| Project | IEEE 802.16 Broadband Wireless Access Working Group < http://ieee802.org/16 > |
| Title | Correction of Figure D.7 |
| Re: | Call for Maintenance Change Requests on IEEE Std 802.16 |
| Abstract | This document suggests correcting Figure D.7 in Annex D.2 Sleep Mode MSCs. |

Figure D.7 – Example sleep mode – MS initiated

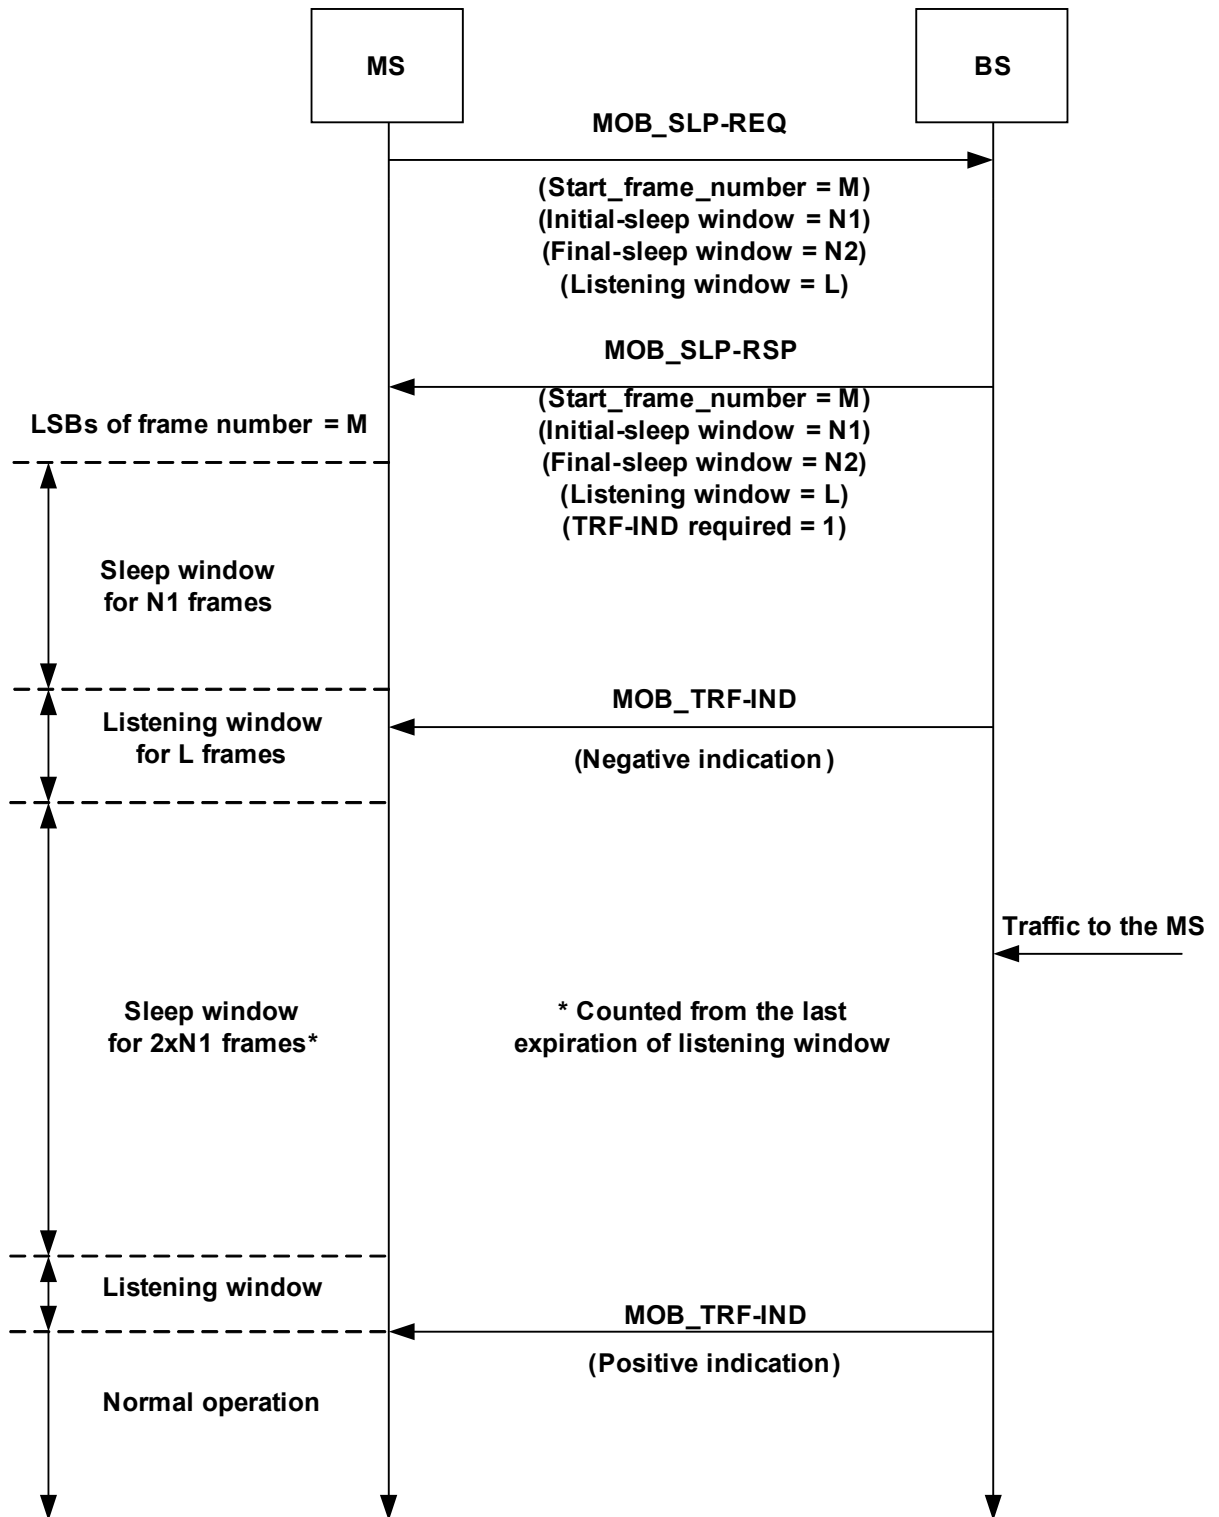
These editorial corrections are required In Figure D.7 of Annex D.2.

- a. Min-sleeping interval and Max-sleeping interval are not defined in sleep mode operation. Those should be Initial-sleep window and Final-sleep window, respectively.
- b. Two notations L' and L1 are used for the Listening interval. It should be L1 in the figure.
- c. Description on the starting point of sleep window is not consistent with description in 6.3.21.2. The size of sleep window should be counted from the last expiration of listening window according to 6.3.21.2 and Figure 130a.

[Adopt a revised figure in the next page as Figure D.7:]
